To: Prity Cleary **Subject:** SDD-10371

Subject: SSD-10371 Trinity Grammar School Redevelopment

Trinity Grammar School Redevelopment SSD 10371

Figure 2

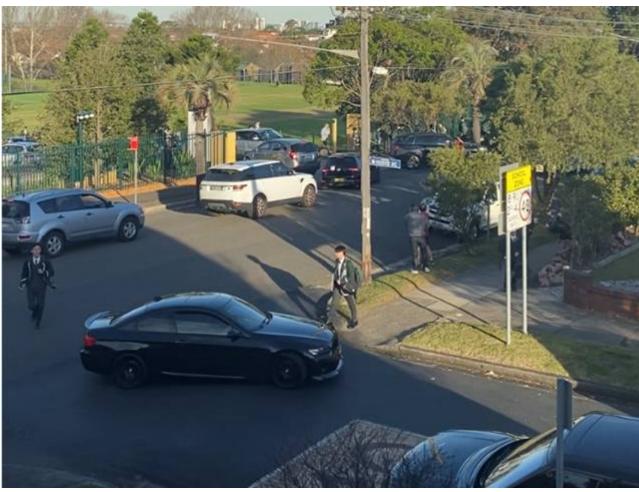
- 2) Please require *structural design amendments* to protect residential amenity rather than rely on self-regulation.
 - a. The increase in student body has the potential to exponentially expand use of ovals (including during the evening, Figure 2). Please condition lighting (internal and external) that automatically switches off according to schedule of uses and prohibit floodlighting.
